Addendum #3 to SJPC-22-51 (Barrier Wall): June 24, 2022

Answers to Potential Bidders' Questions

**BID FORM – SECURITY PERIMETER BARRIER WALL AT BALZANO MARINE
TERMINAL (REVISED 6/24/22)**

CONSTRUCTION PLAN
 SCALE: 1" = 30'

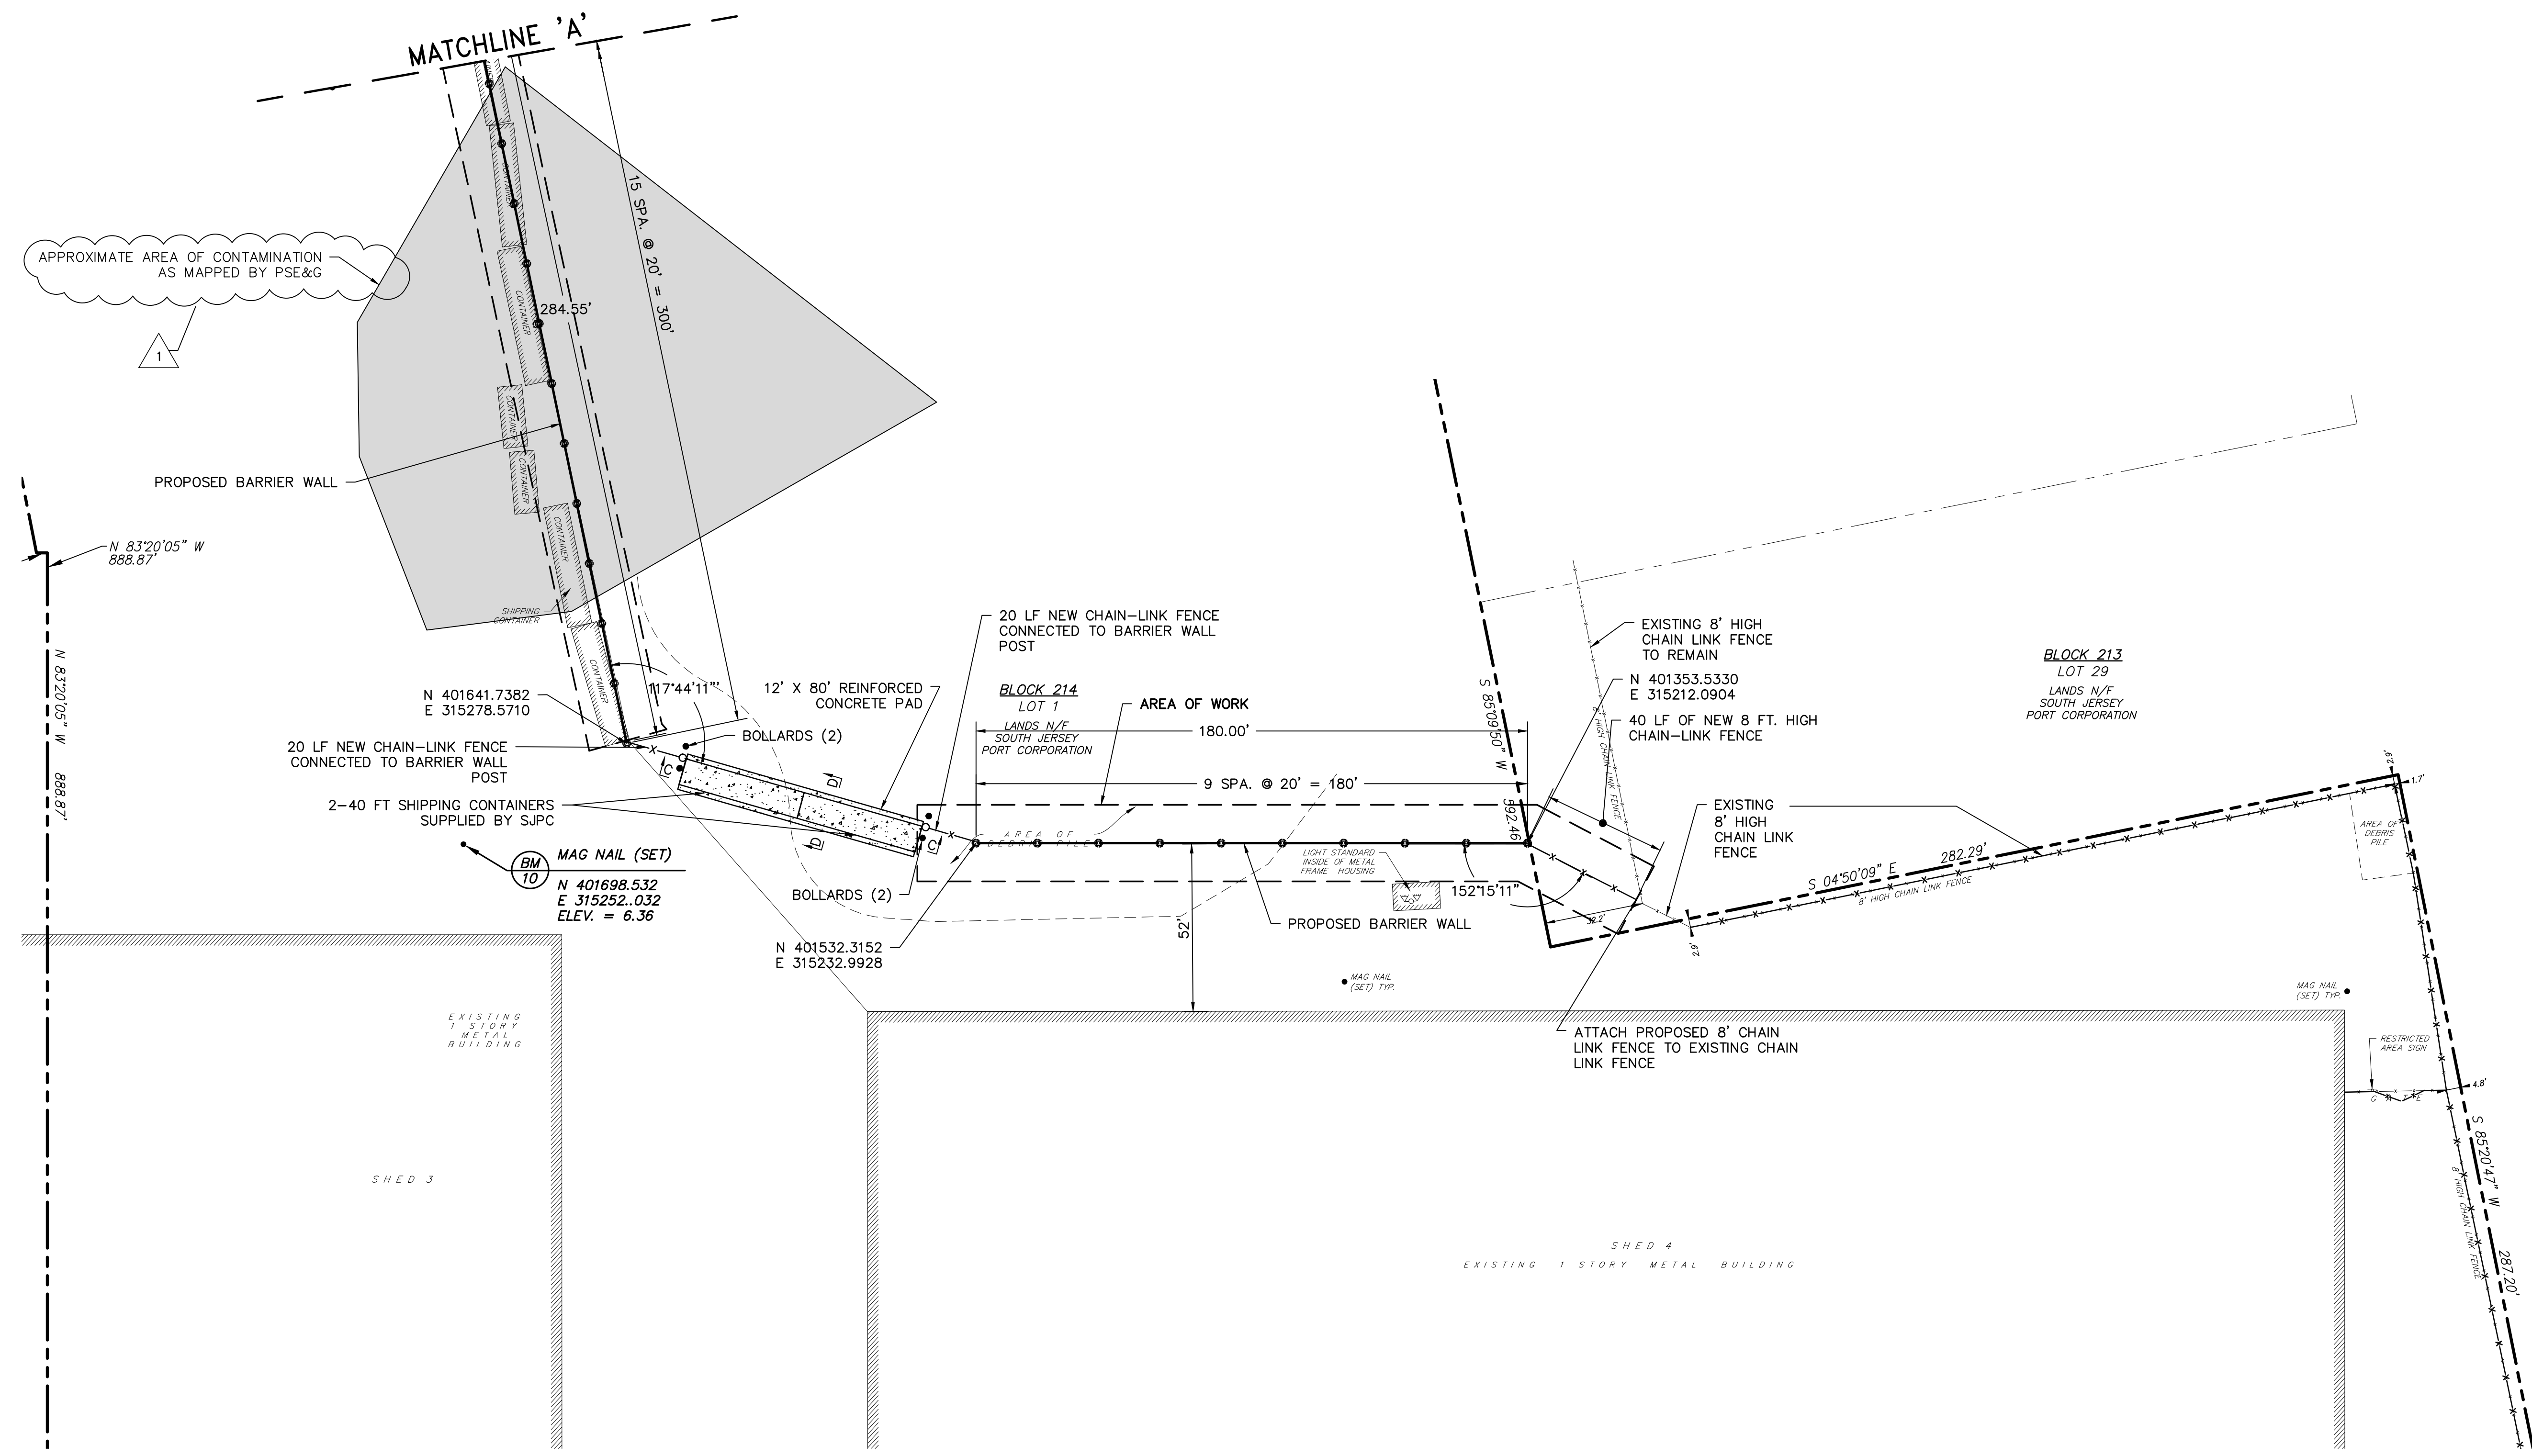
Q1: Kindly provide an overlay drawing showing the contaminated PSE&G area on the Security Wall Drawings.

NO.	REVISION	DATE	BY	CHK
1	ADD APPROVAL LOCATION OF CONTAMINATION	06/24/22	DMS/KCW

A1: Please see attached revised drawings.

OVERALL SITE PLAN
 SCALE: 1" = 40'

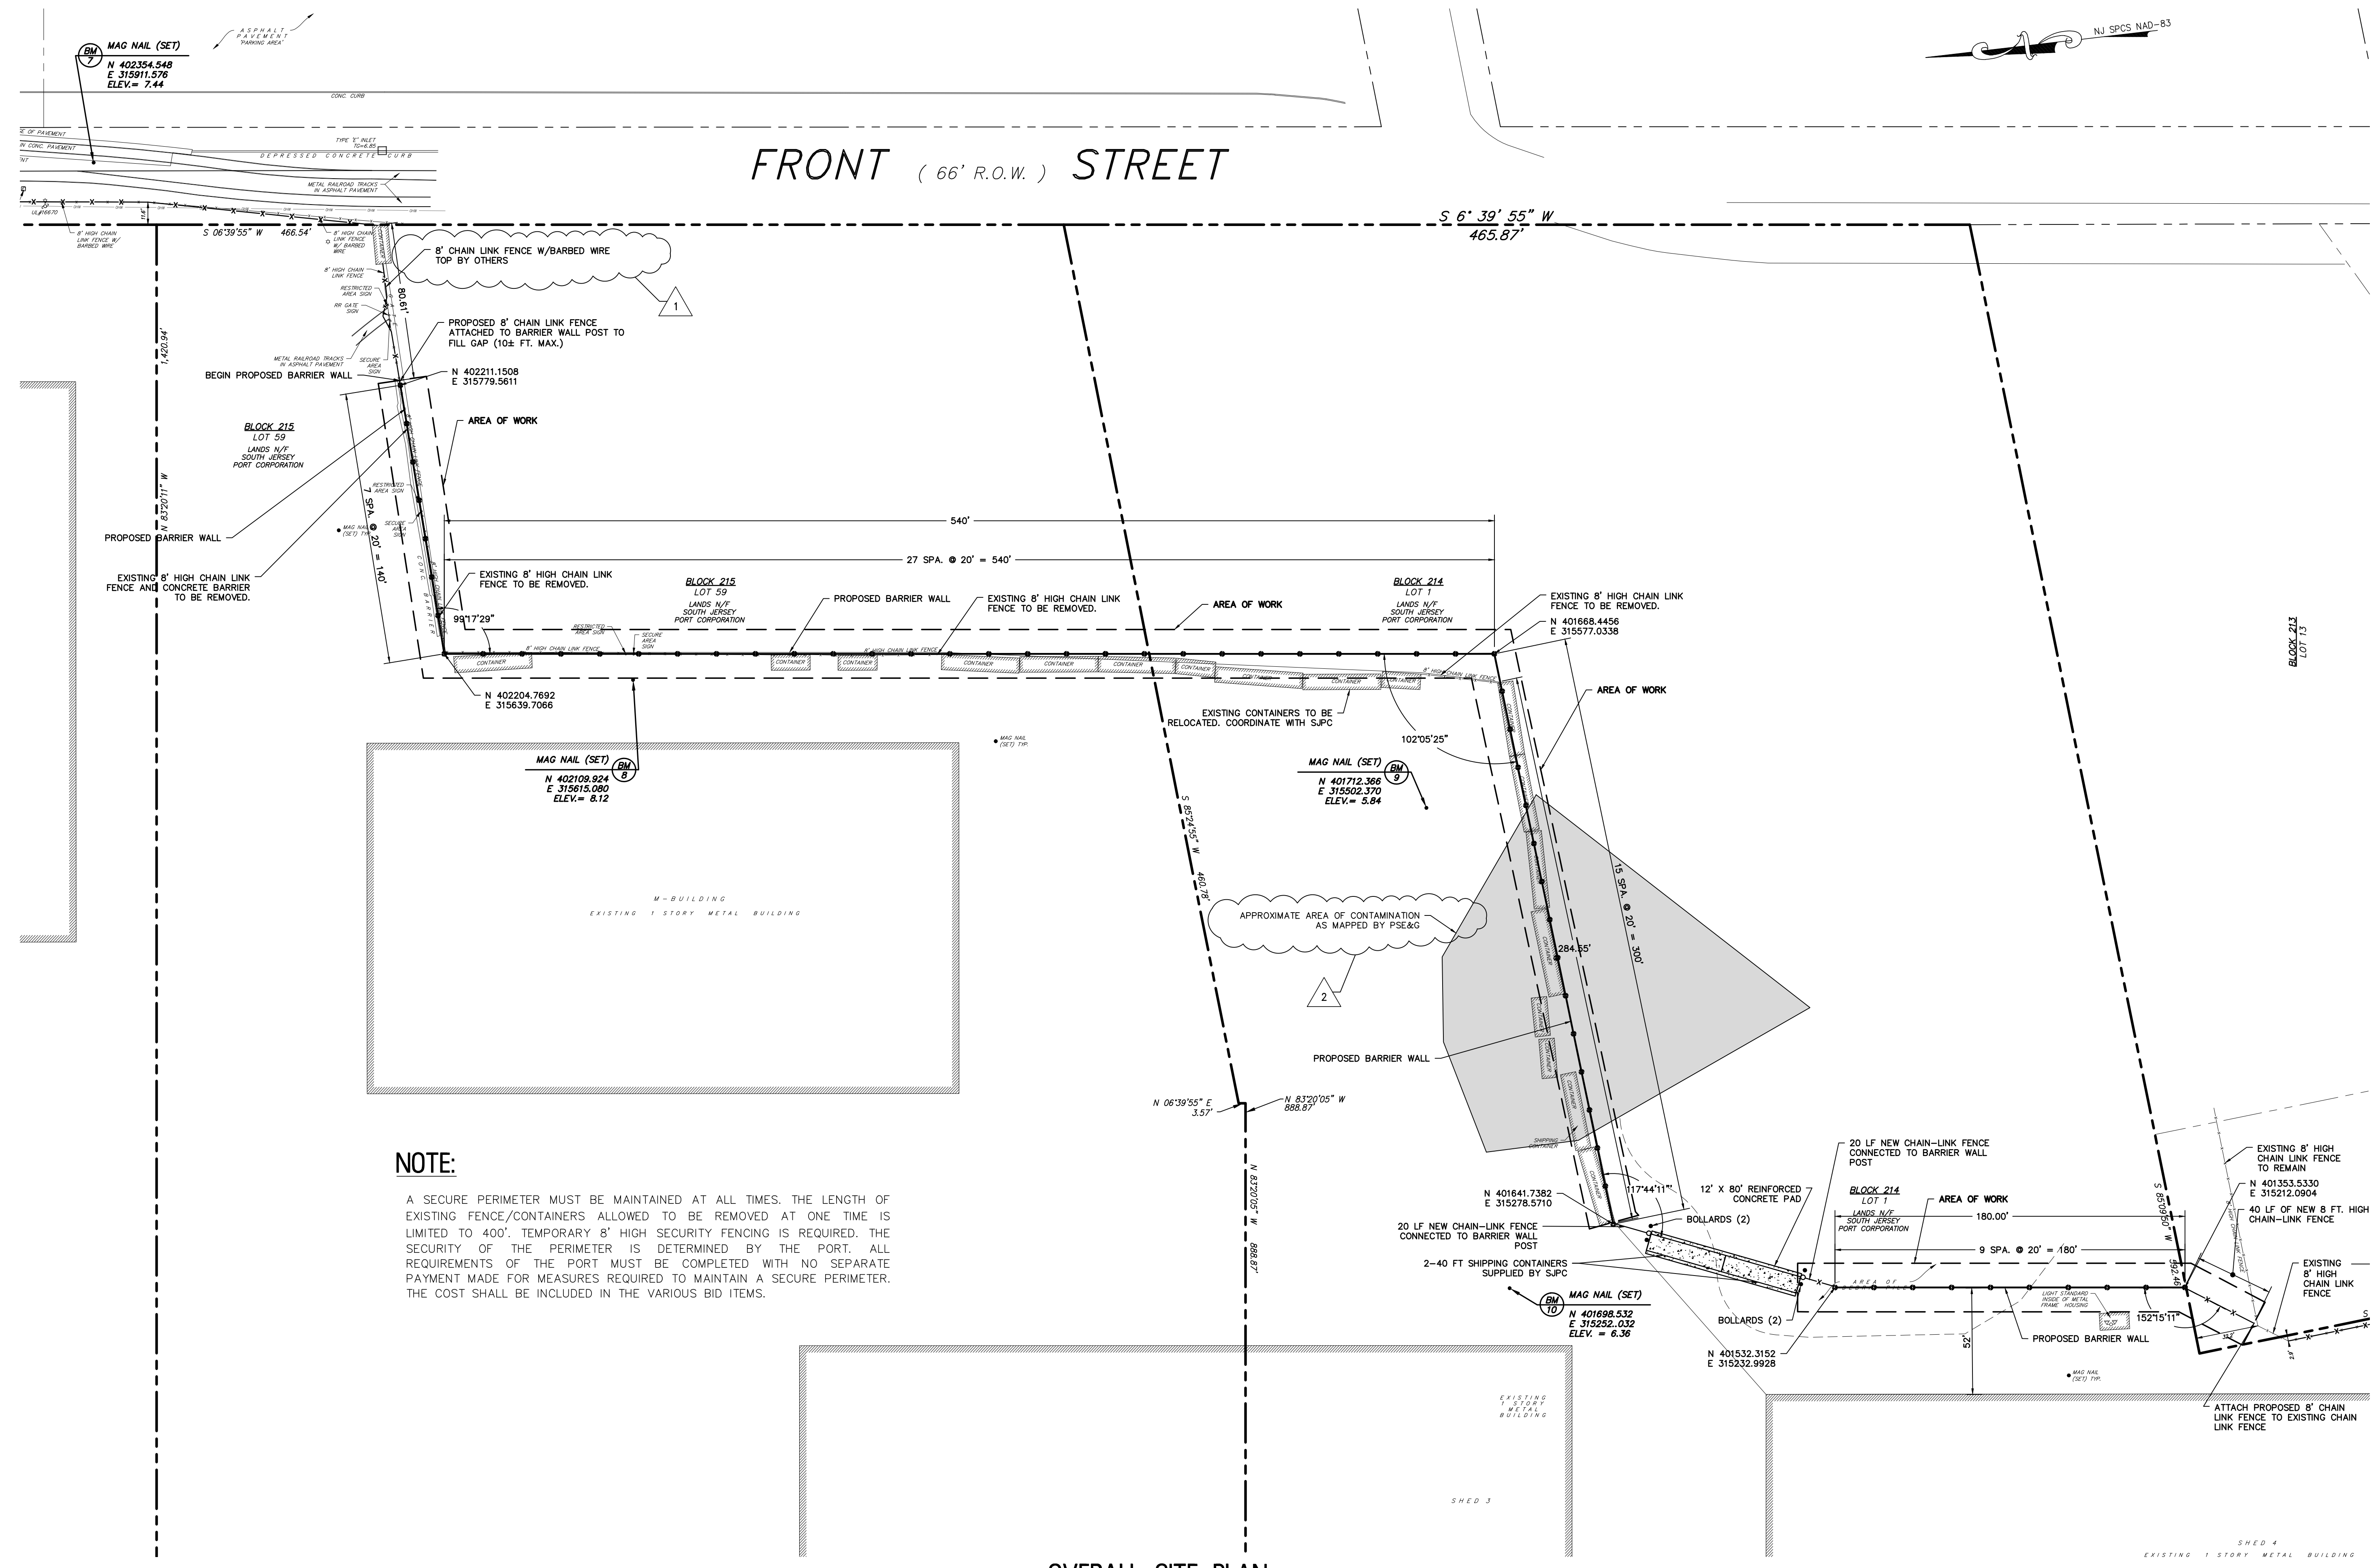
Q5: Please delineate the fencing that is currently being installed on-site through another subcontract versus the fencing required to be installed as part of this subcontract.

No.	REVISION	DATE	BY
2	ADD APPROX. LOCATION OF CONTAMINATION	06/24/22	DMS/KCW
1	ADD EXISTING FENCE CALL-OUT	06/23/22	CFC/KCW

A5: See attached revised plan sheets 4 of 9 and 6 of 9.
